MODIFICATION SHEET NO. RDSO/2022/EL/MS/0490 (Rev. '0') dated 09.09.2022

Modification to avoid Speedometer OFF & ON during running of train/locomotive due to VCU reset in three phase electric locomotives.

Figure -1 (VCU Reset Scheme)

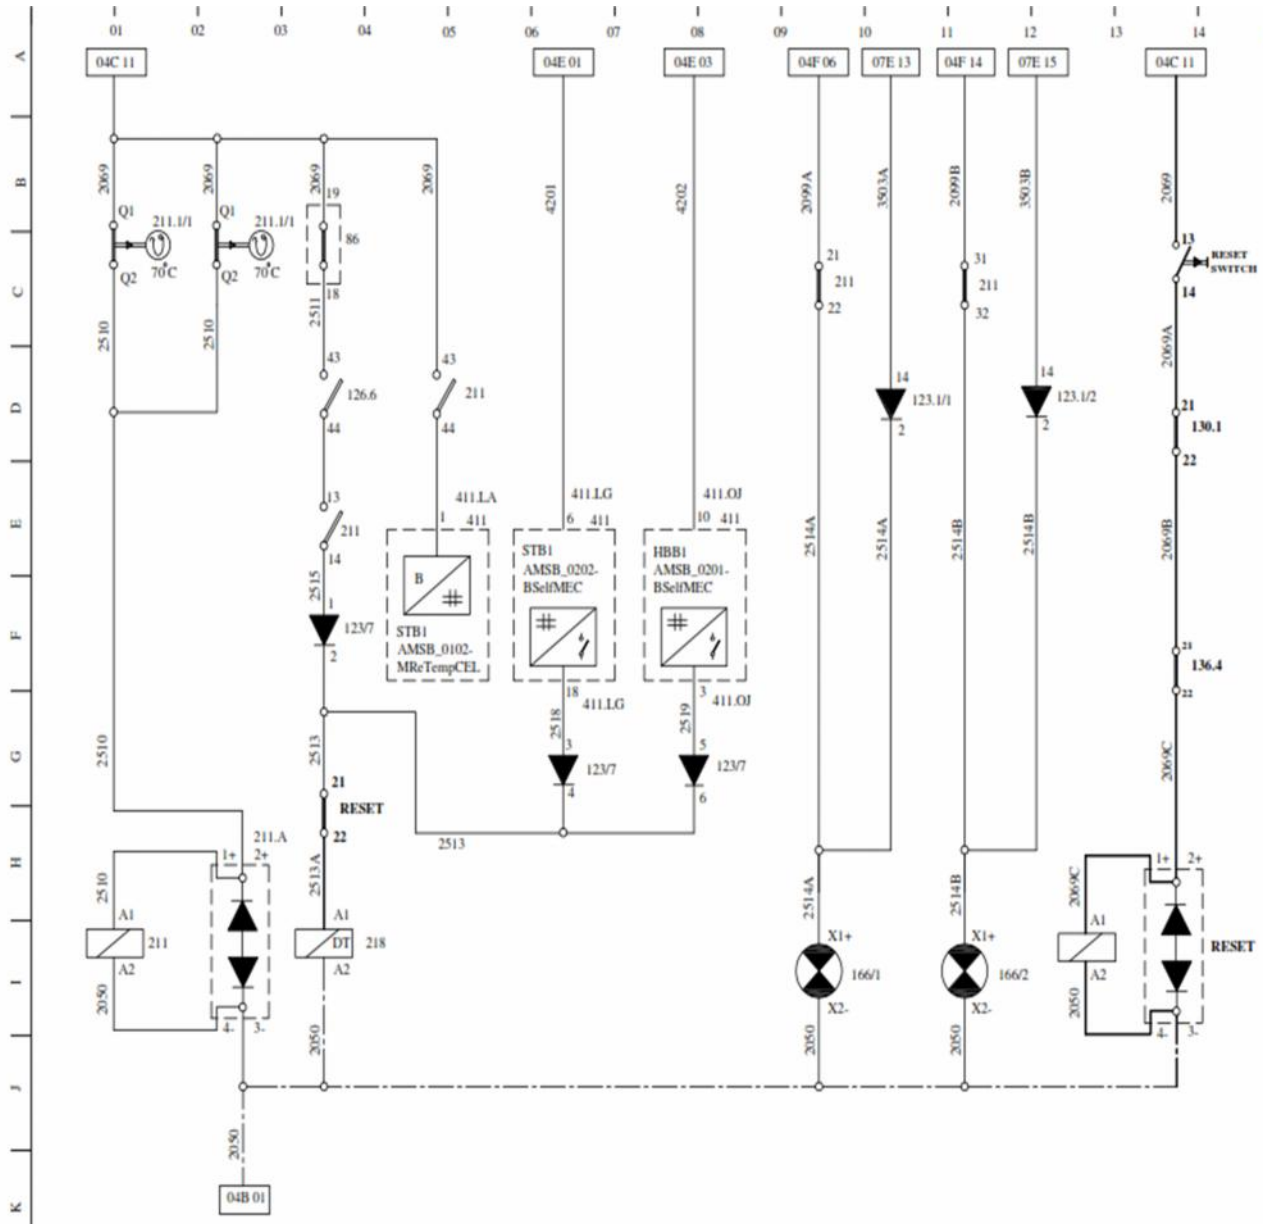
It is to be mentioned that Speedometer also getting OFF & ON with VCU reset during running condition of train/locomotive by operating VCU reset switch due to their power supply in common path. When VCU reset switch is pressed, VCU reset relay gets de-energized and its interlock on contactor 218 coil branch gets opened leading to coil of contactor 218 de-energize causing contactor 218 to get open circuited. Due to this,

incoming power supply coming from contactor 218 through wire no. 2096 to Speedometer MCB (127.92) got interrupted leading to Speedometer OFF.

5.0 Modified Speedometer Scheme:

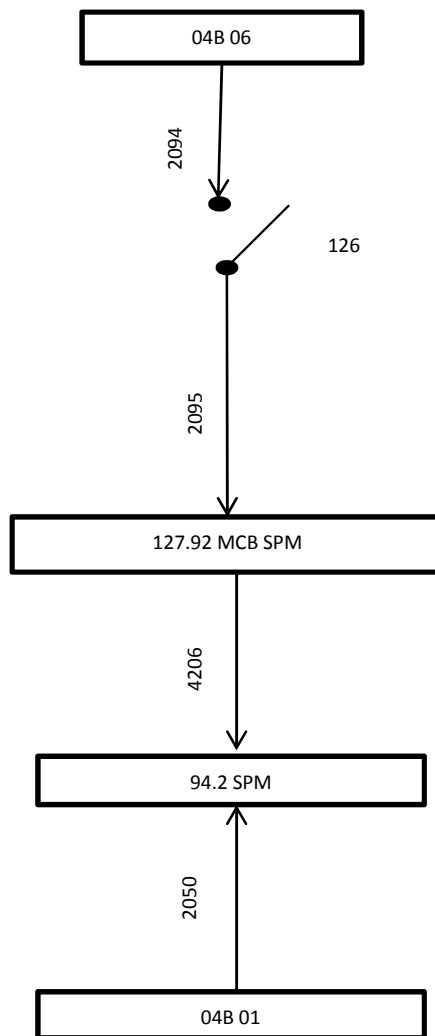
As described in Para 4, it is not feasible to do VCU reset without Speedometer OFF & ON as per existing Scheme. In view of this, following modification is proposed in control supply wiring of Speedometer circuit to avoid its OFF & ON during VCU reset. In this modified scheme, input supply to speedometer MCB will be fed from output of contactor no. 126 through wire no. 2095. Modified scheme is given as under.
